AGENDA
PLANNING AND ZONING COMMISSION MEETING
CITY OF CREVE COEUR, MISSOURI
MONDAY, FEBRUARY 4, 2019

APPLICATION TO PLANNING AND ZONING COMMISSION #18-050 FOR A MINOR SITE PLAN APPROVAL FOR THE EXTERIOR MODIFICATION TO THE BUILDING AT 453 N. LINDBERGH BOULEVARD

EXTERIOR RENOVATION FOR:
PEELE PROPERTIES
453 N LINDBERGH BLVD
CREVE COEUR, MO 63141

Figure 1: Revised front elevation

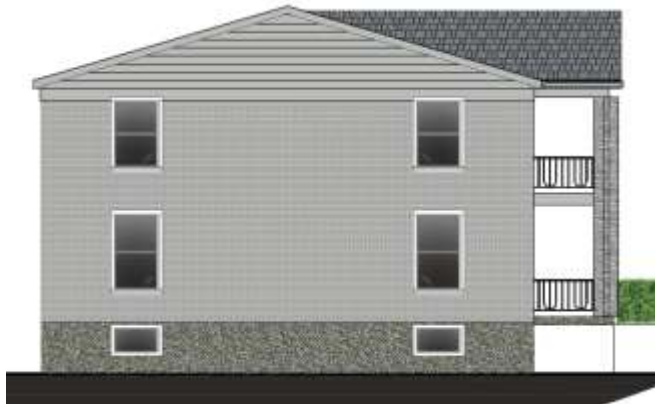
The Applicant has revised the drawings to address the Commission's concerns from the prior meeting. The elevations include new stacked stone columns, as well as made them more substantial in appearance. The new gable roofs are a gray fiber cement Hardie Board material to better coordinate with the rest of the building. The overall structure painted a light grey color, instead of the beige. The Applicant will have material and color samples for the Commission's review at the meeting.

Staff believes that the change to the design and materials of the building addresses the Commission's comments from the previous meeting; however, the Commission should review the materials samples with the Applicant at the meeting.

Figure 4: Revised Site/Landscape Plan from January 22, 2019 Staff Report

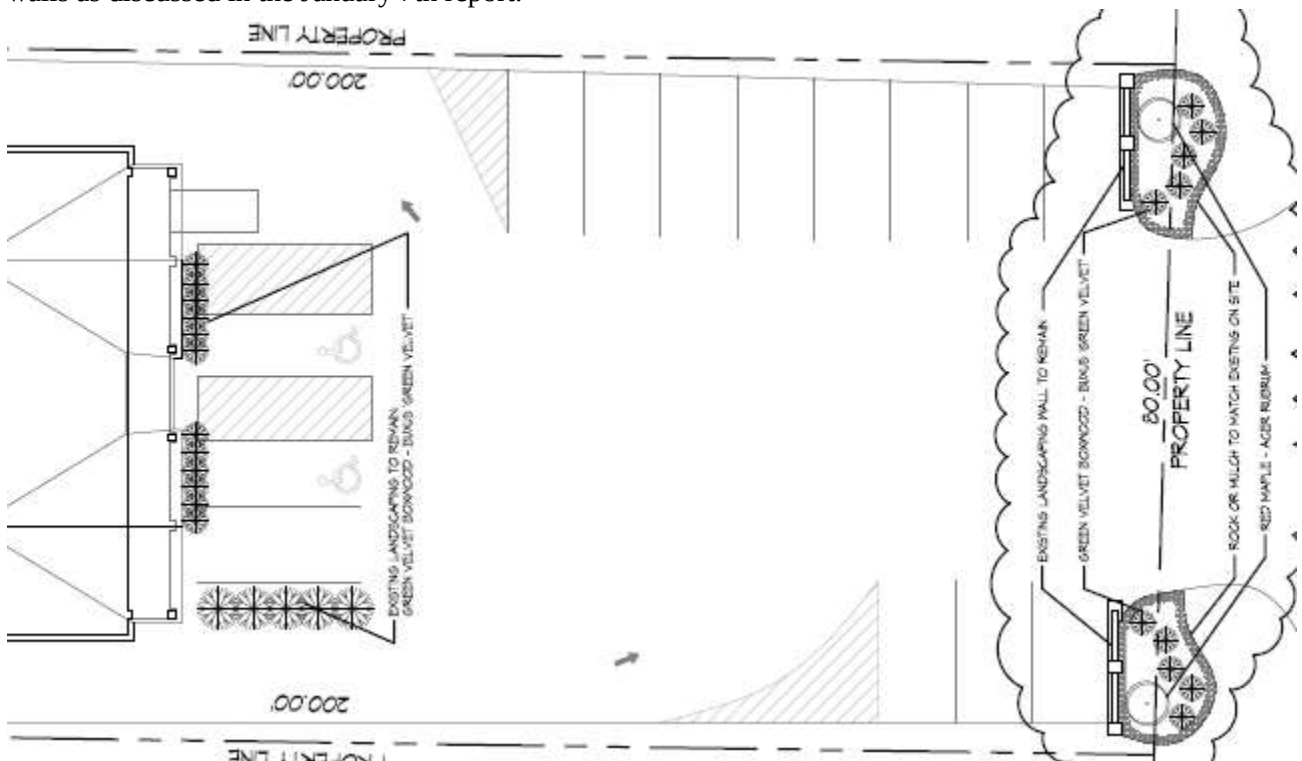
For the January 22, 2019 meeting, the Applicant also provided a revised Landscape plan to include two new red maple trees on either side of the entrance, and boxwood shrubs to soften the existing landscaping walls as discussed in the January 7th report.

6. The Landscape Plan shall be revised to indicate that the trees shall be a minimum of 3" caliper to comply with Section 405.540(F)(1) of the Landscaping Ordinance.

Figure 4: Revised Site/Landscape Plan

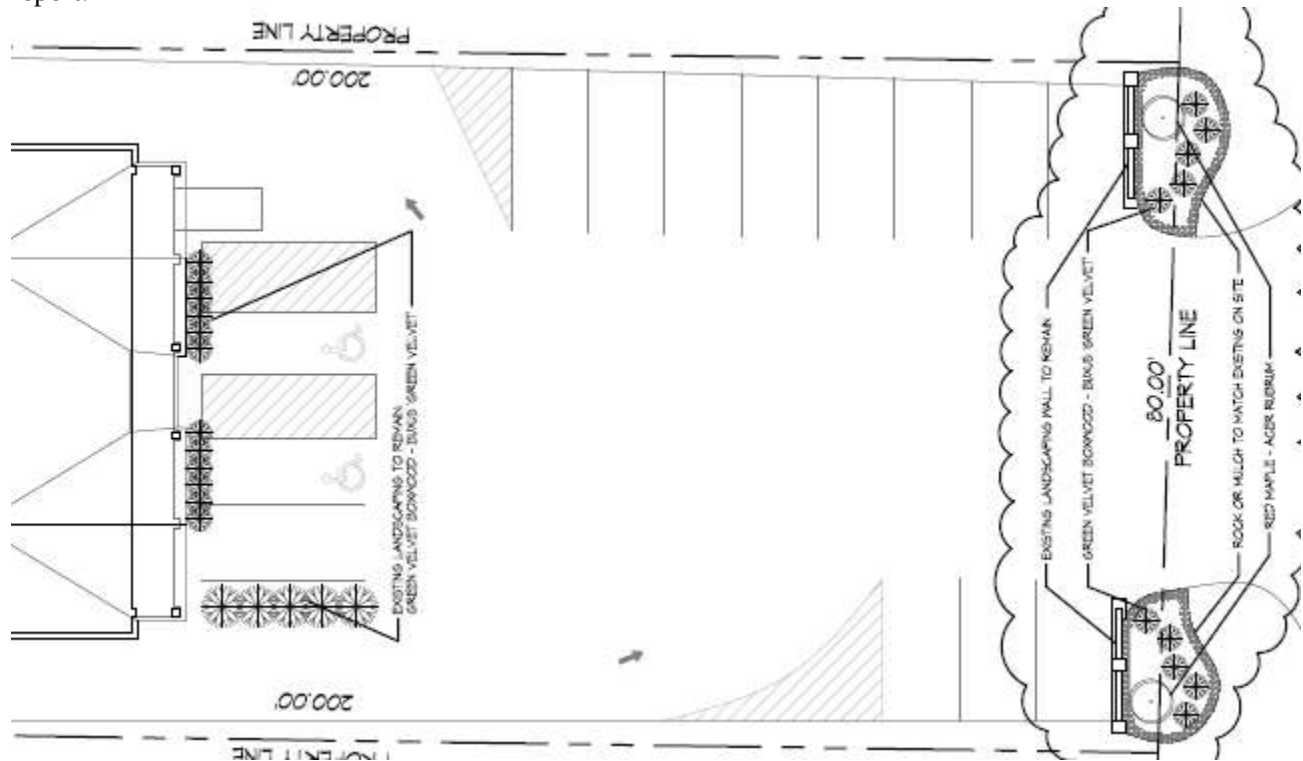
The Applicant also provided a revised Landscape plan to include two new red maple trees on either side of the entrance, and boxwood shrubs to soften the existing landscaping walls as discussed in the prior report.

Figure 12: Close-up of the 1996 Landscape Plan on the left and the Applicants proposed Landscape Plan on the right.

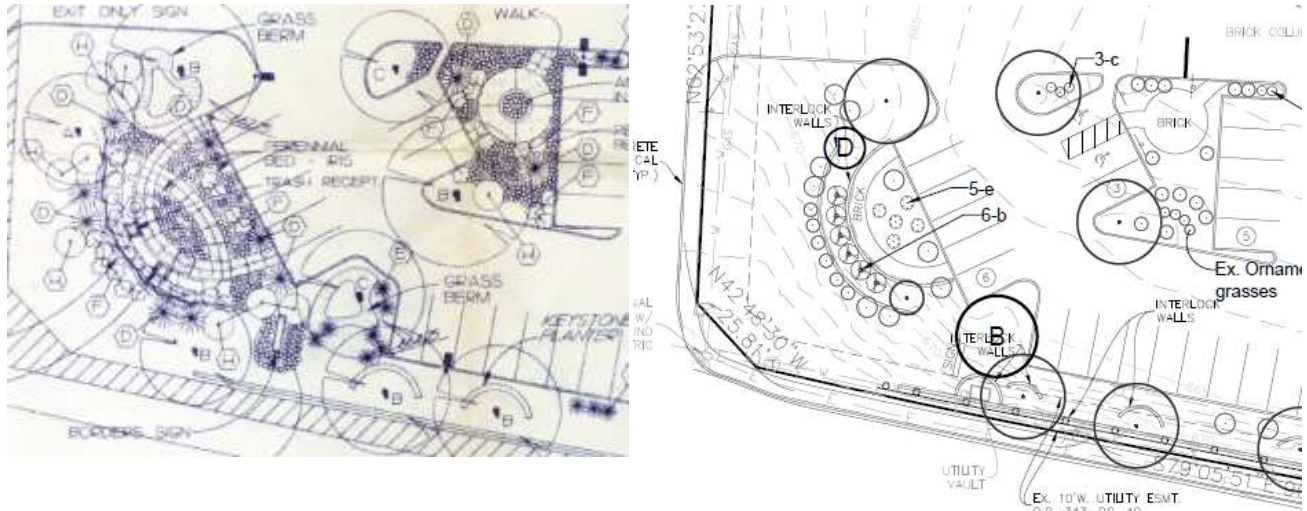
Staff finds that the proposed landscaping does not meet with the same level of material and design as the prior approved plans, particularly at the southwest corner area and along Olive Boulevard. Therefore, Staff has included a condition of approval that a revised Landscape Plan be submitted for Staff approval to provide for additional plant materials along Olive Boulevard and N. New Ballas Road at the seating area and landscaped median to match the level of design and materials for the site coverage bonus of the prior approved Plans.

Figure 13: Close-up of the proposed facade improvement with the LED Lighting indicated.

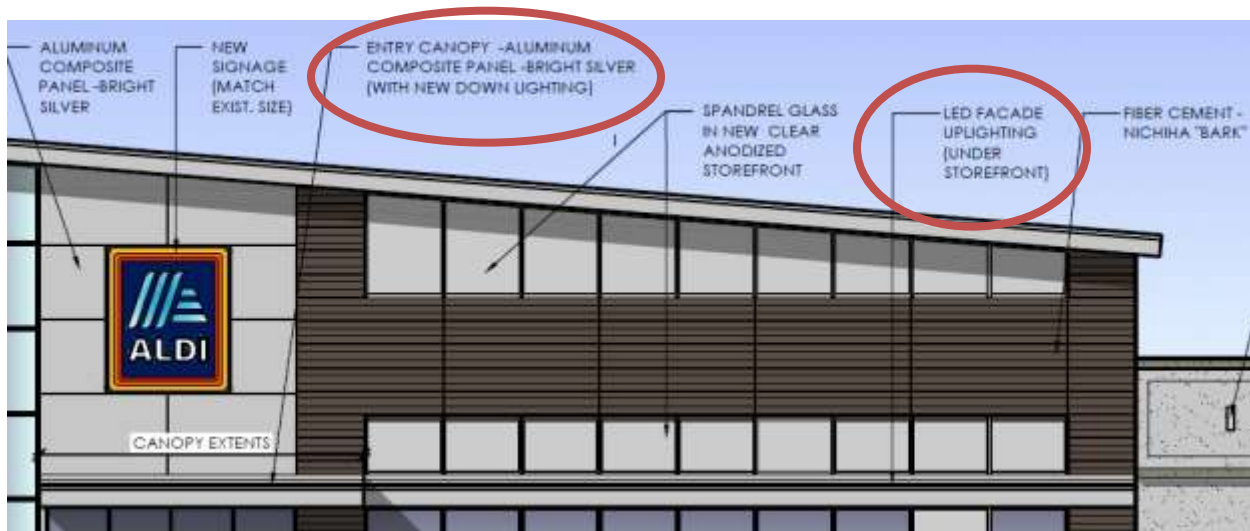
While no photometrics were provided, the lighting proposed is meant to illuminate the building façade, shining directly onto the surface, and not cast outward to create a glare from the illumination source. Therefore, Staff does not have a concern with the proposed lighting. A condition of approval has been included to require that all lighting shall be in compliance with Section 405.680 of the Zoning Ordinance.
